MEMORANDUM

Subject: Addendum to MovingAhead Alternatives Analysis Technical Reports

This document is an addendum to the MovingAhead Project's Alternatives Analysis (AA) Draft Final Technical Reports, dated May 2017. This addendum serves to provide new options for mitigating potential adverse effects as related to the information gathered by the AA Technical Reports.

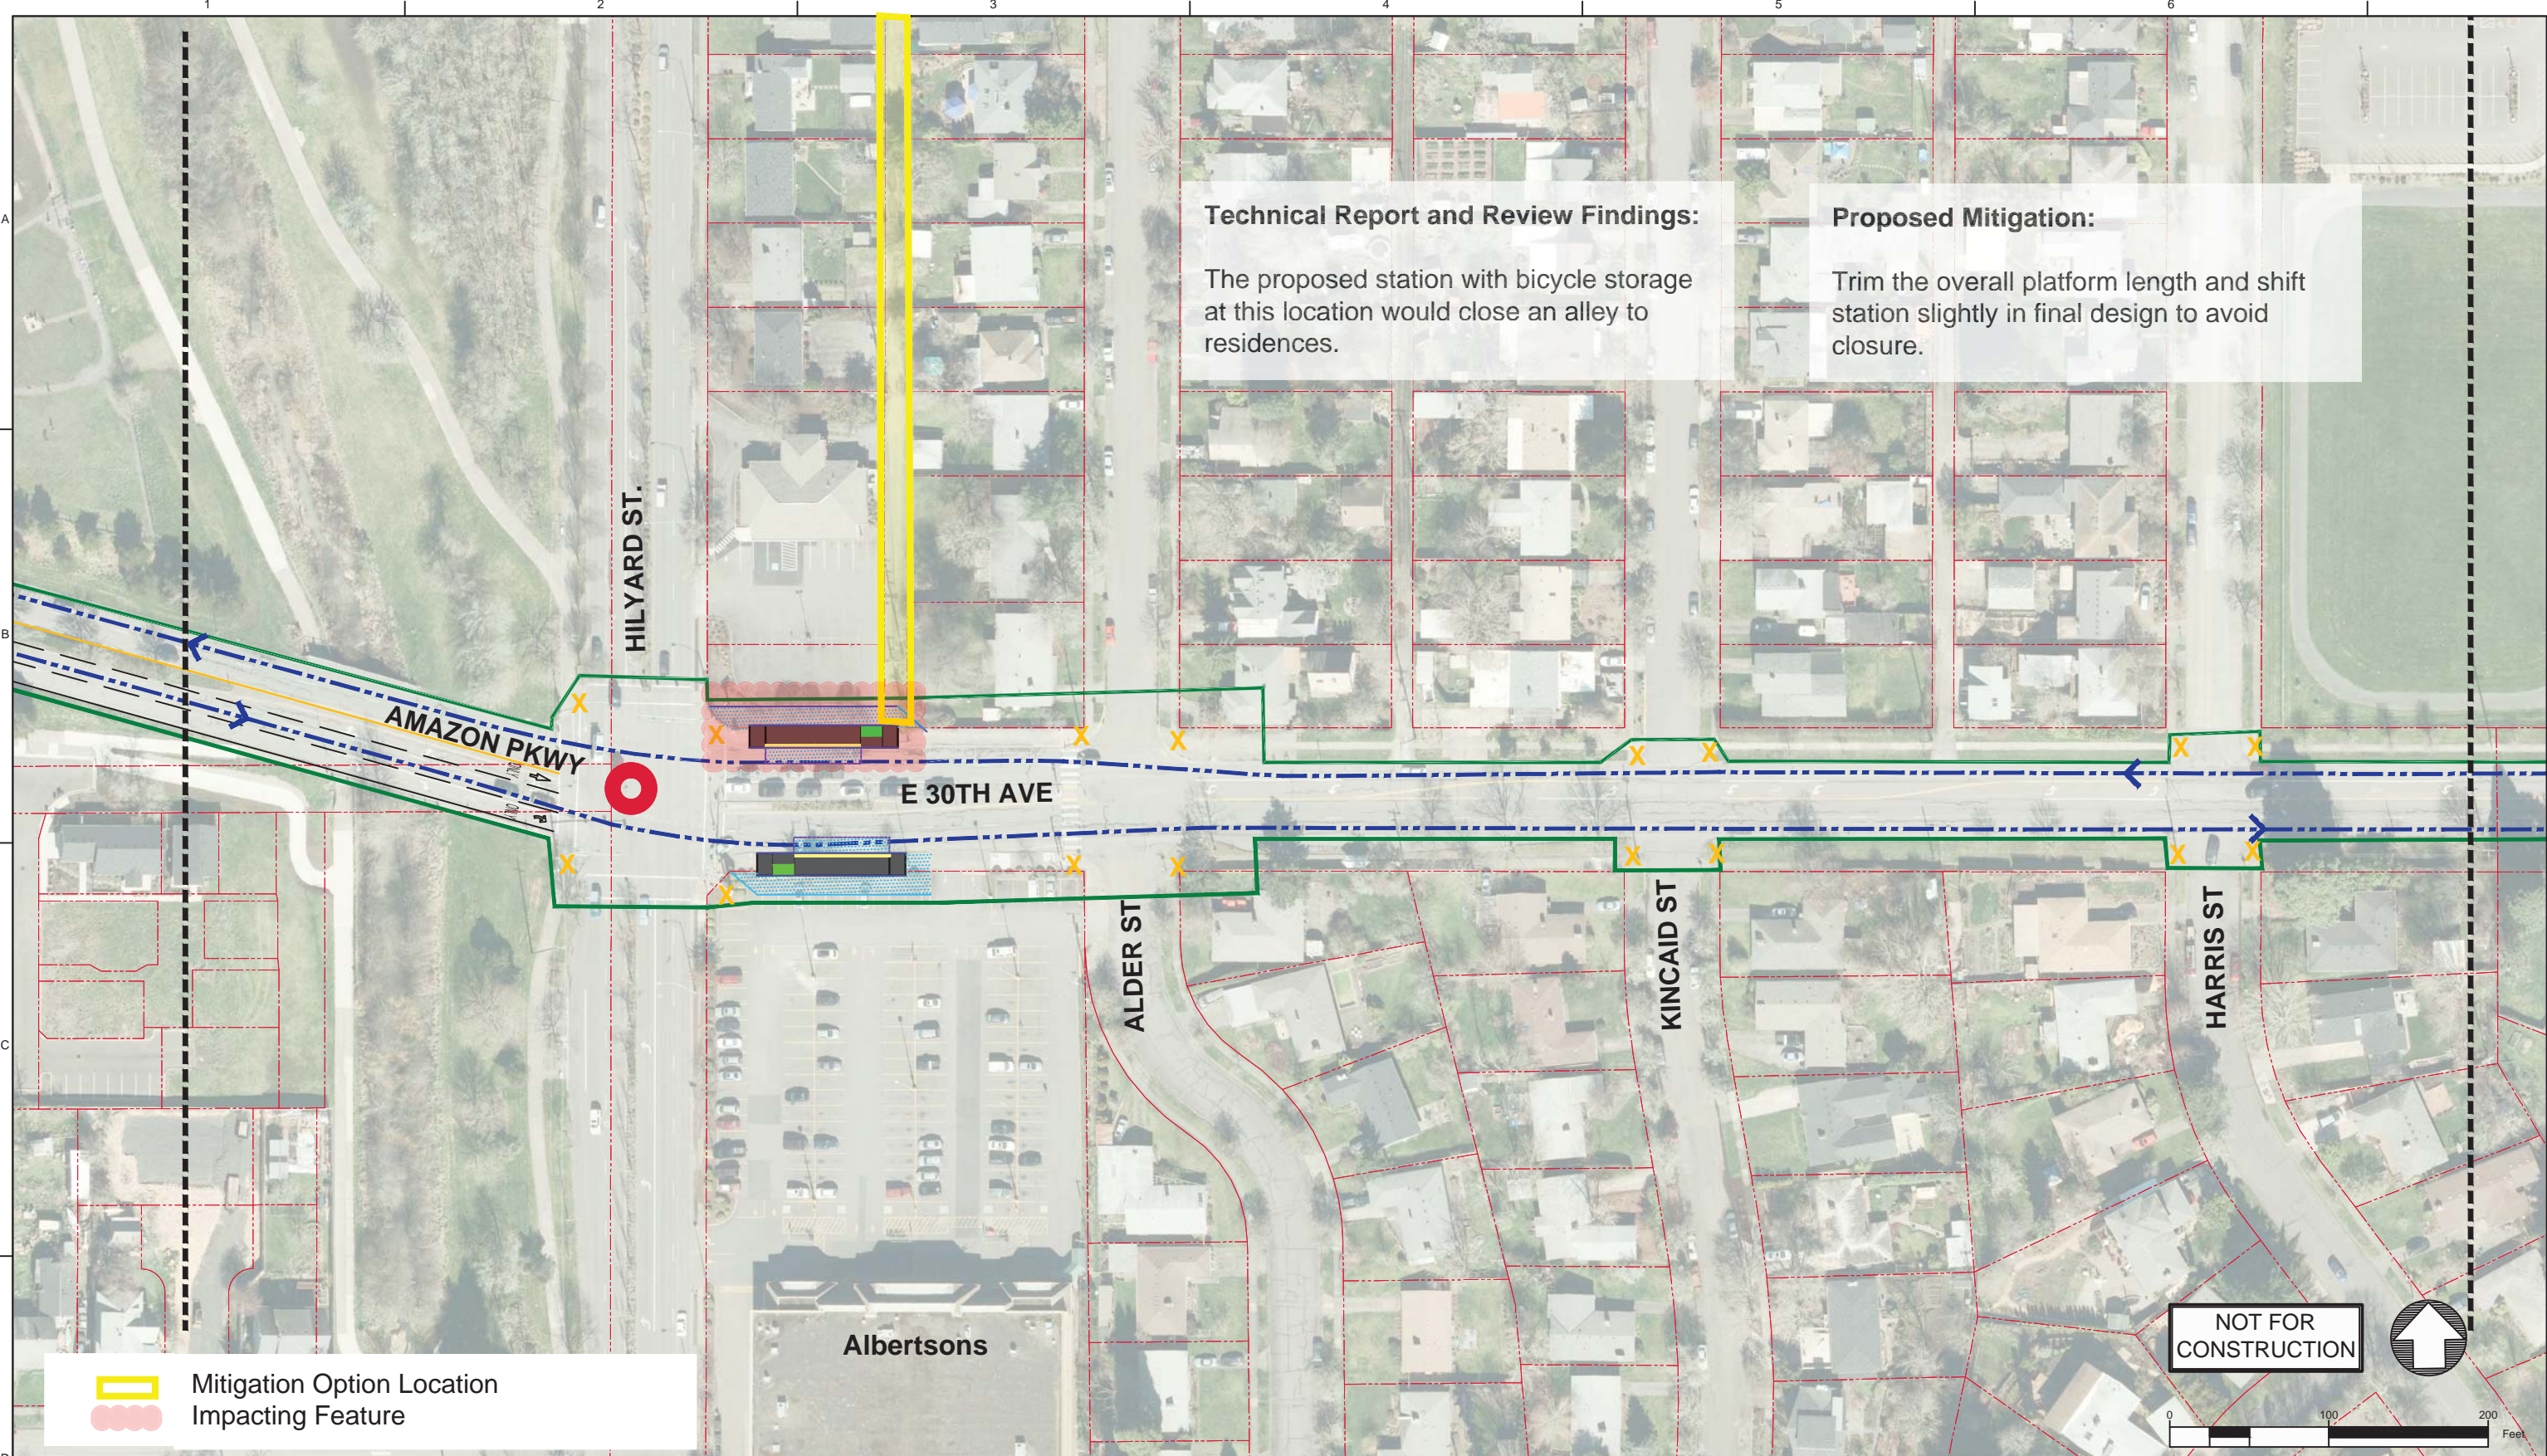
Technical Report and Review Findings:
 The proposed station with bicycle storage at this location would close an alley to residences.

Proposed Mitigation:
 Trim the overall platform length and shift station slightly in final design to avoid closure.

A-21

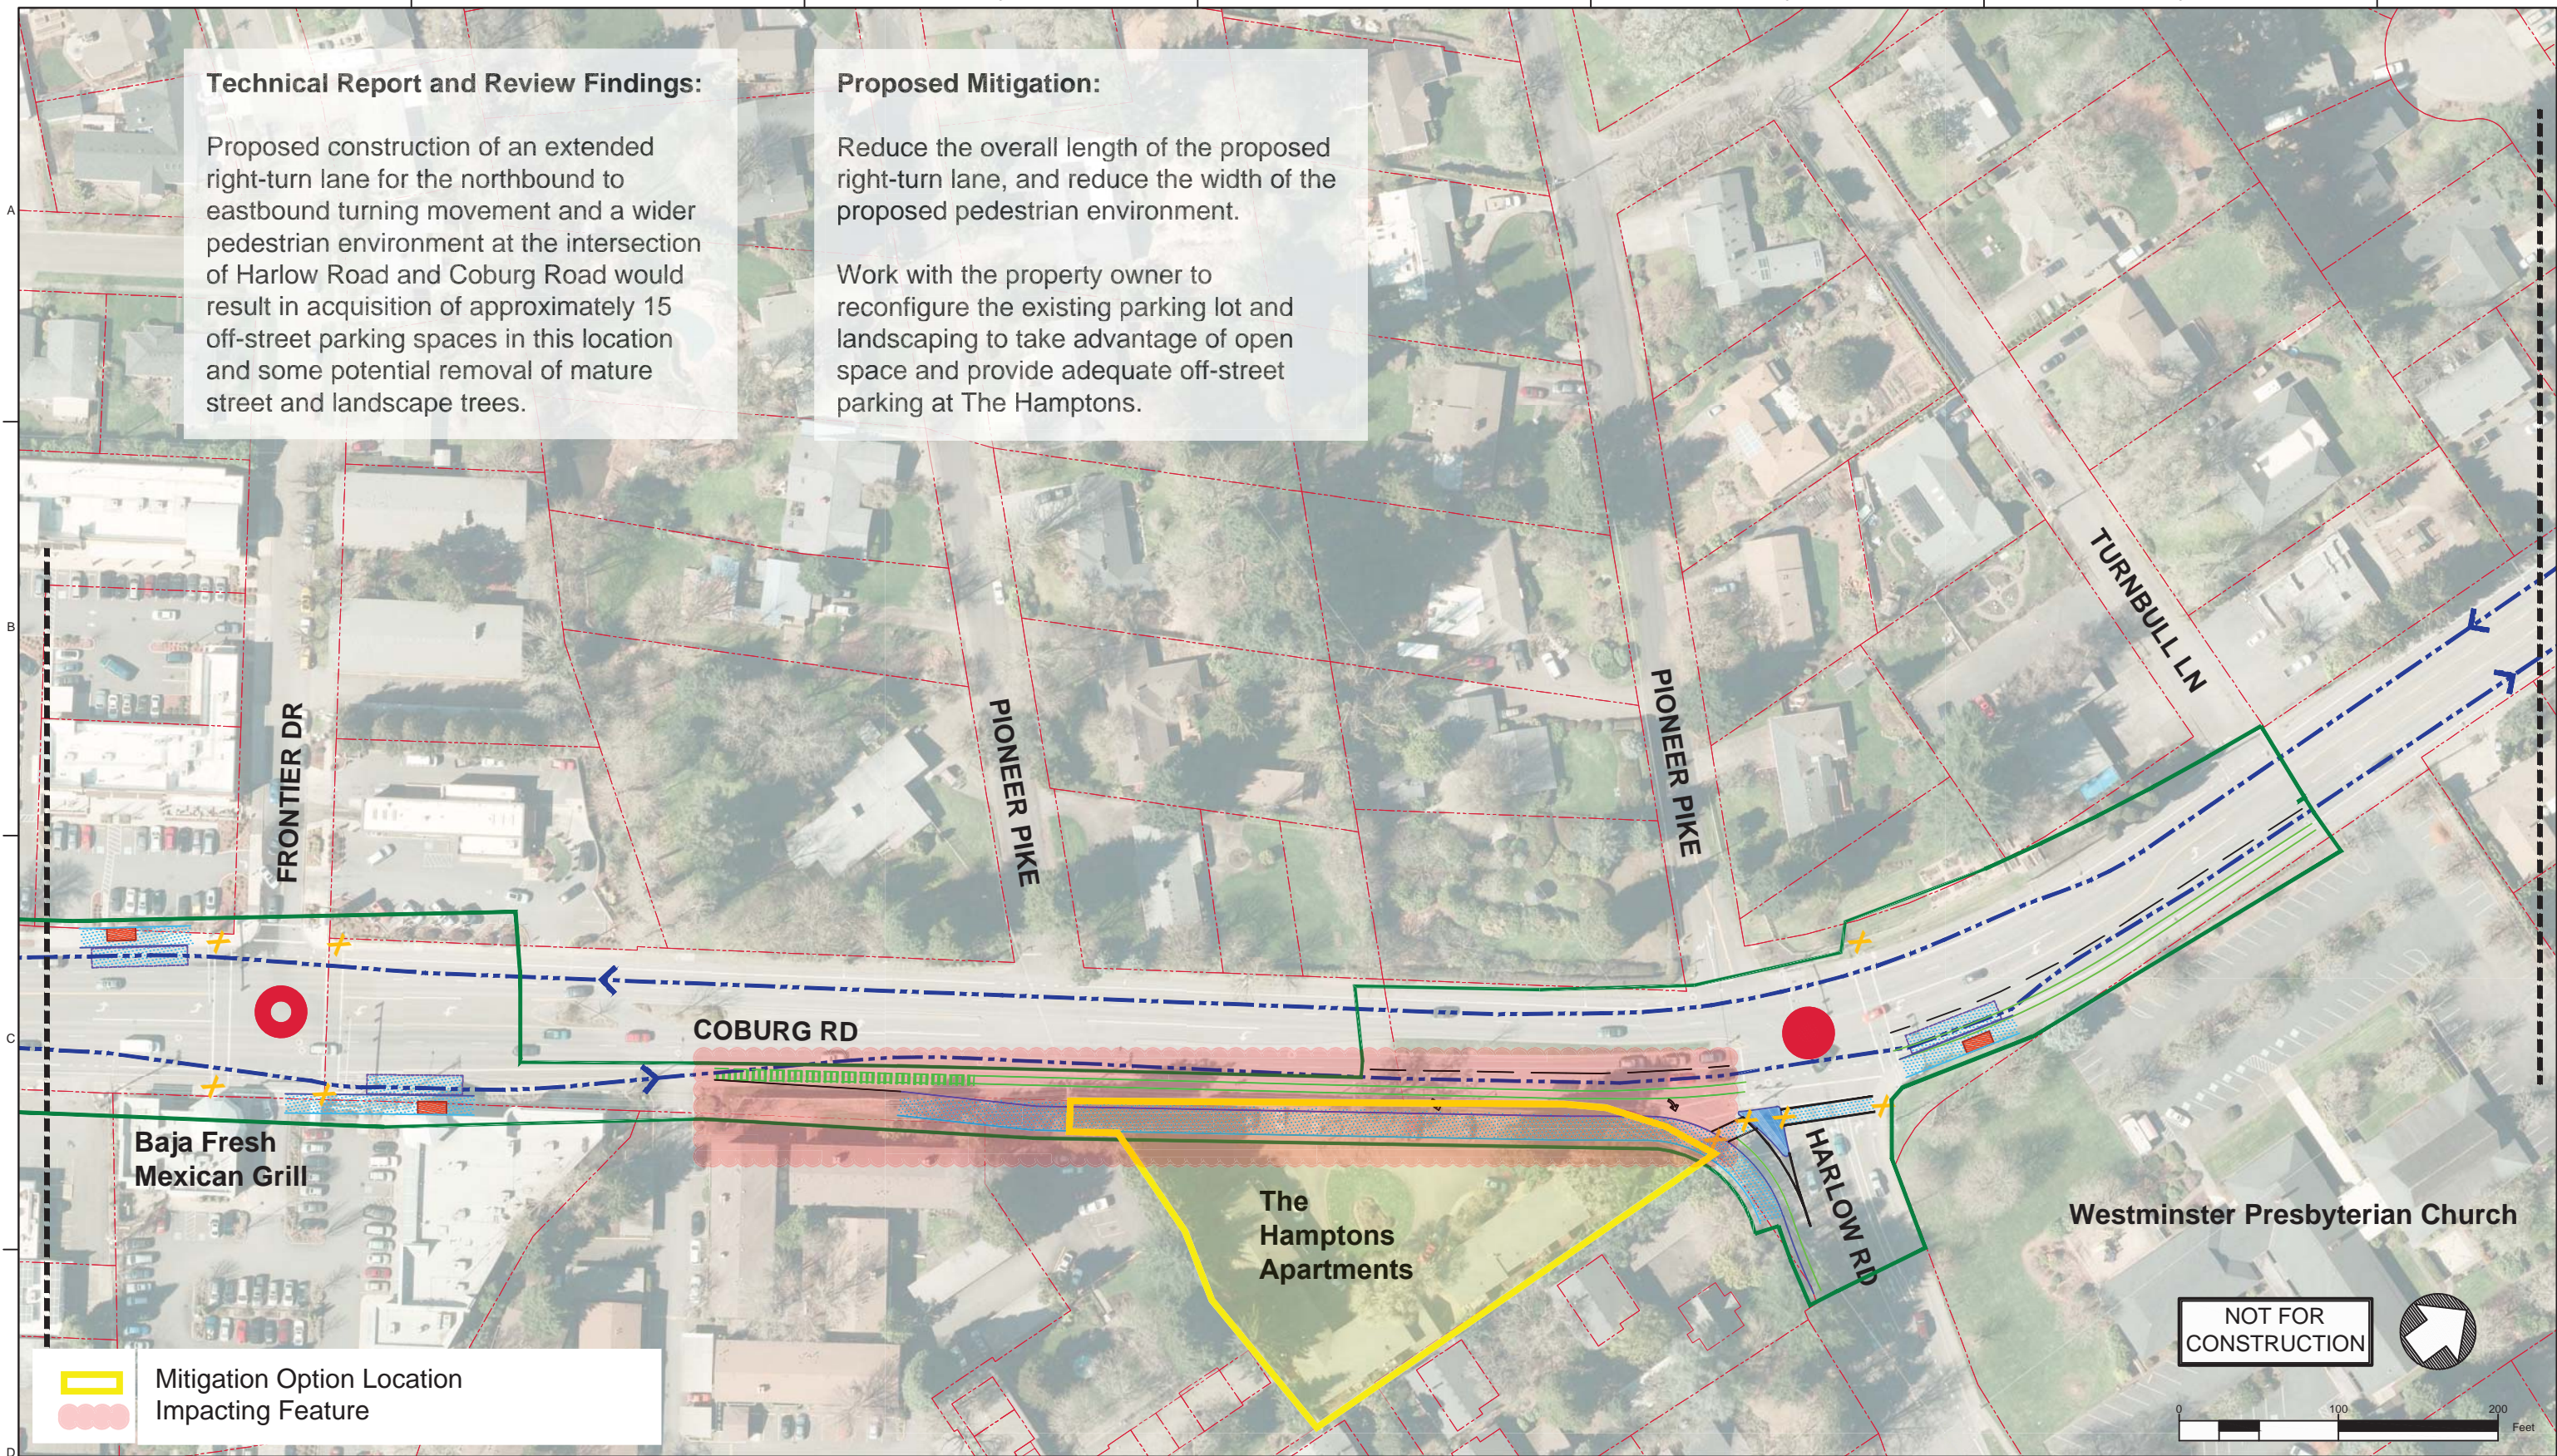
Proposed construction of a new southbound BAT lane and reconstruction of existing shared use path and landscape strip in this area would result in widening and acquisition of approximately eight off-street parking spaces in this location as well as potential reconstruction of the business' parking lot lighting.

**COBURG ROAD CORRIDOR
ENHANCED CORRIDOR ALTERNATIVE**
Local Mitigation: The Hamptons Apartments

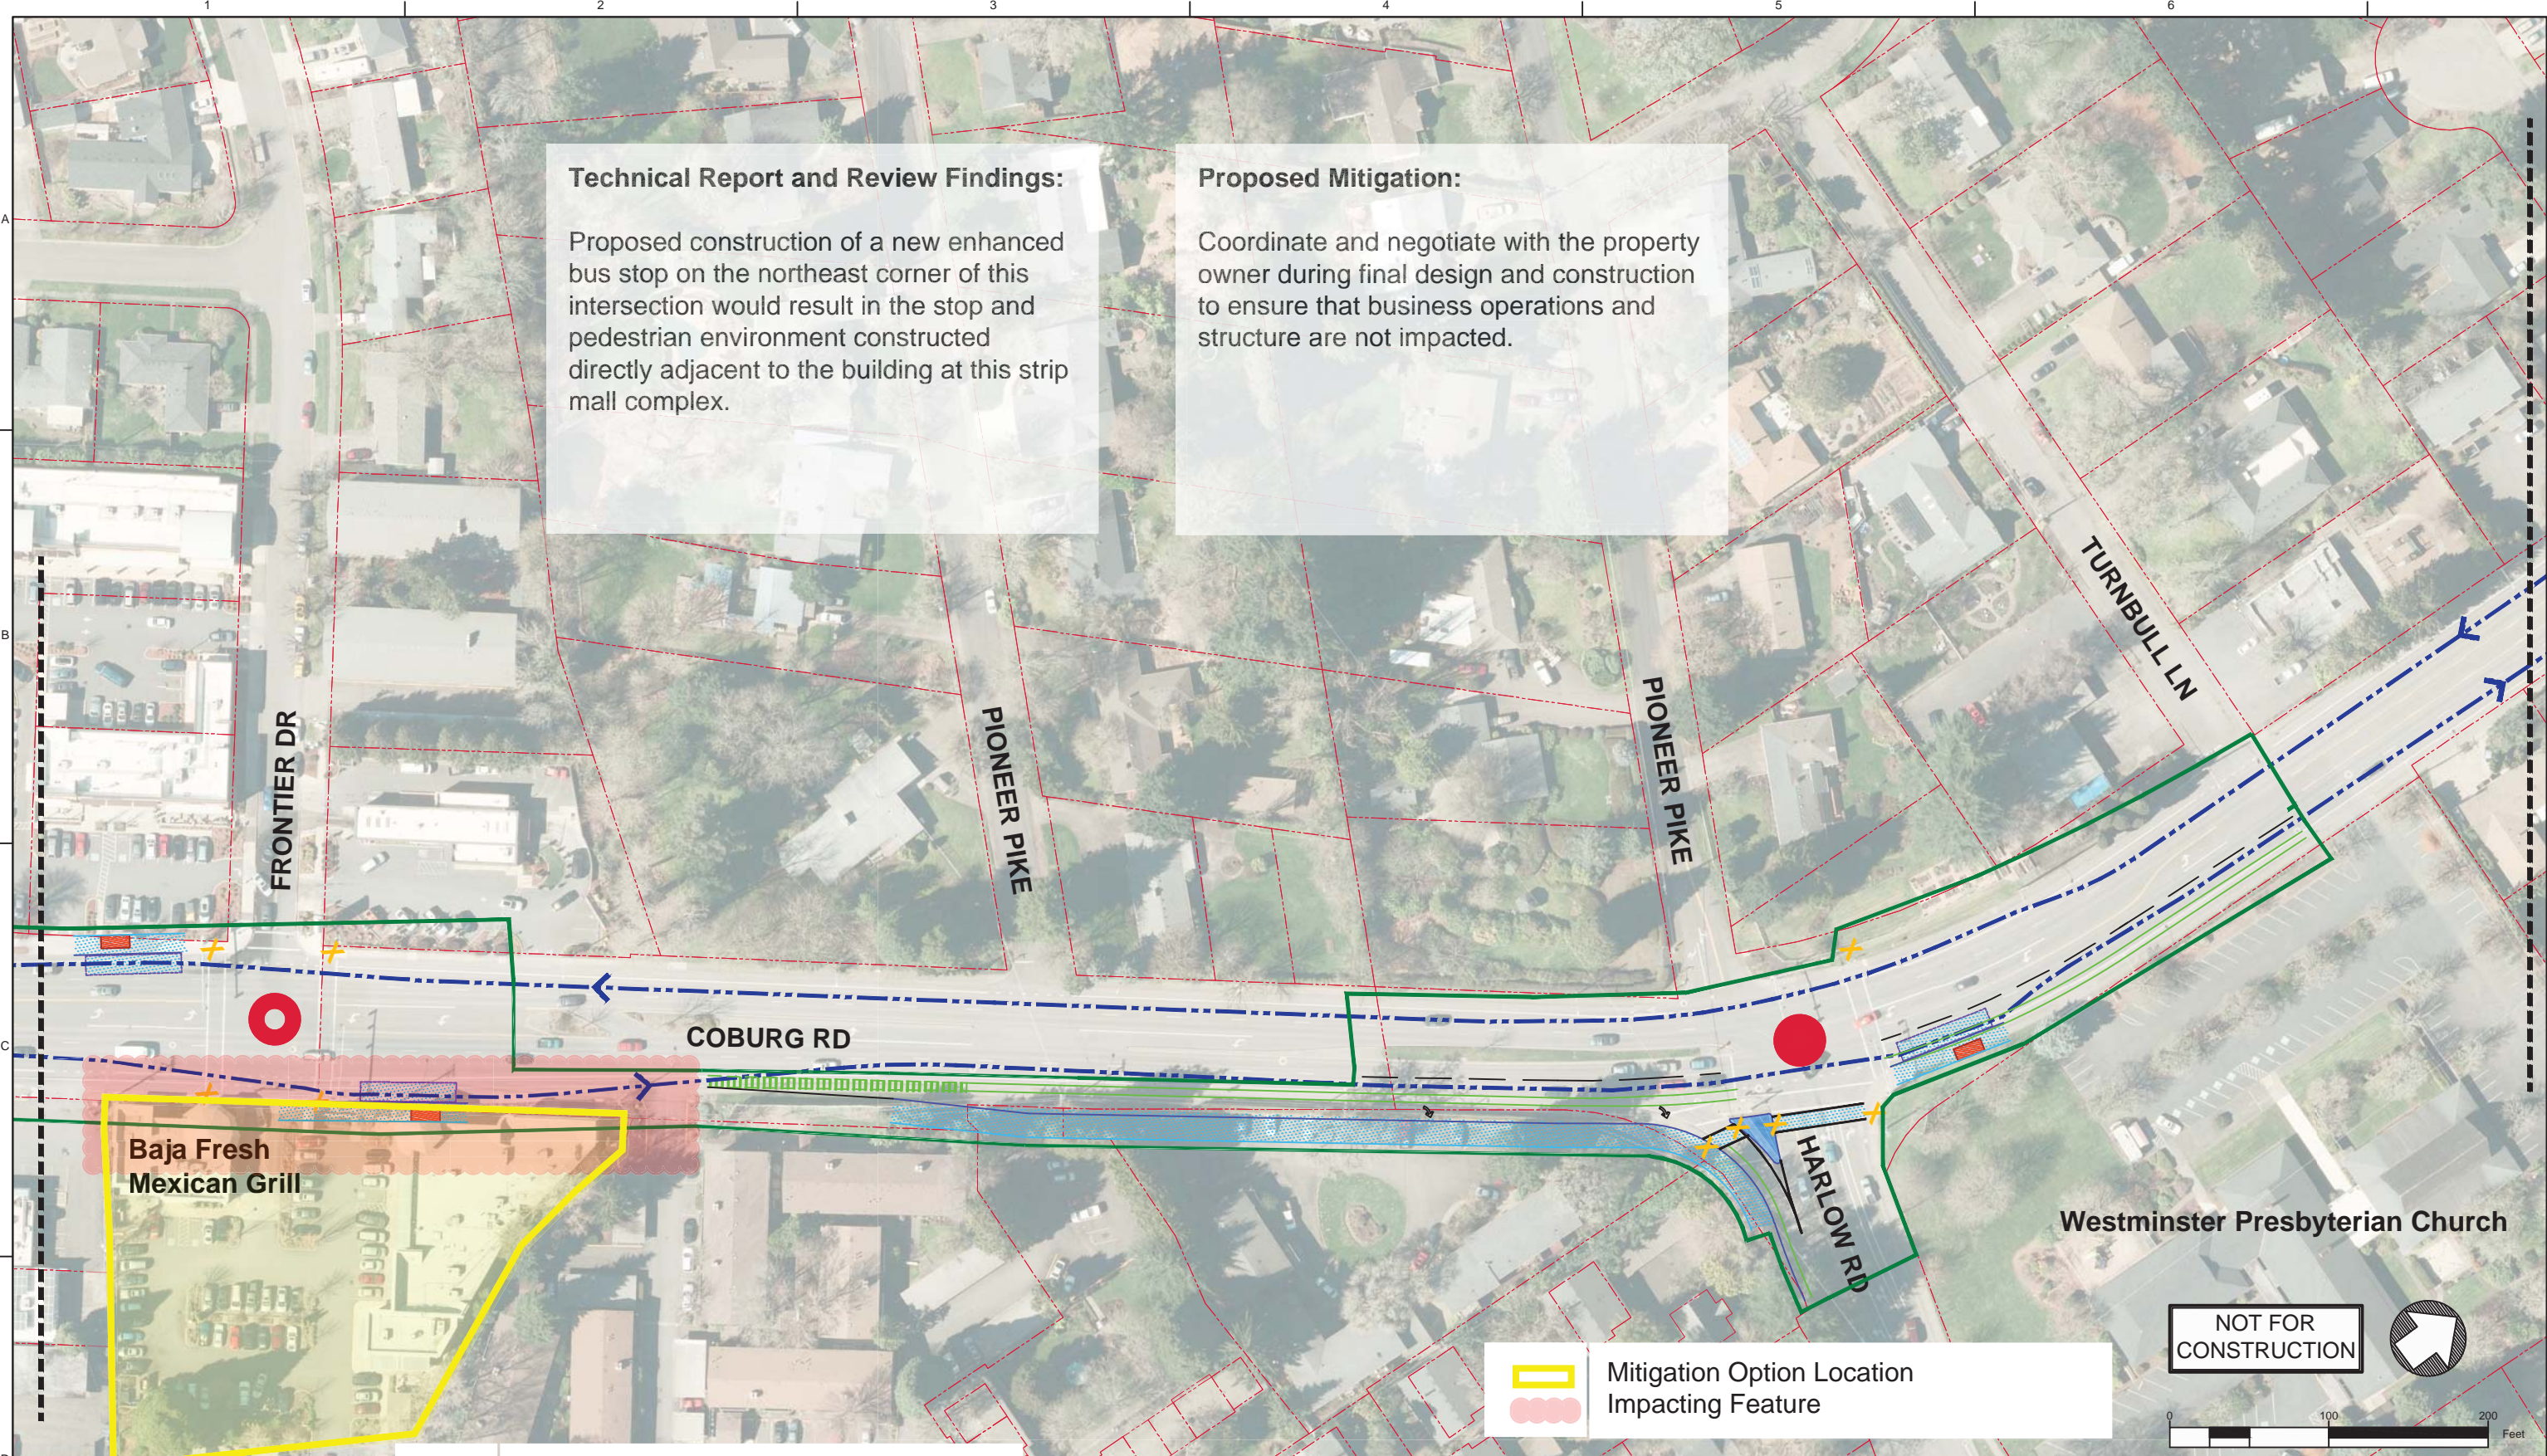
Proposed construction of an extended right-turn lane for the northbound to eastbound turning movement and a wider pedestrian environment at the intersection of Harlow Road and Coburg Road would result in acquisition of approximately 15 off-street parking spaces in this location and some potential removal of mature street and landscape trees.

Work with the property owner to reconfigure the existing parking lot and landscaping to take advantage of open space and provide adequate off-street parking at The Hamptons.
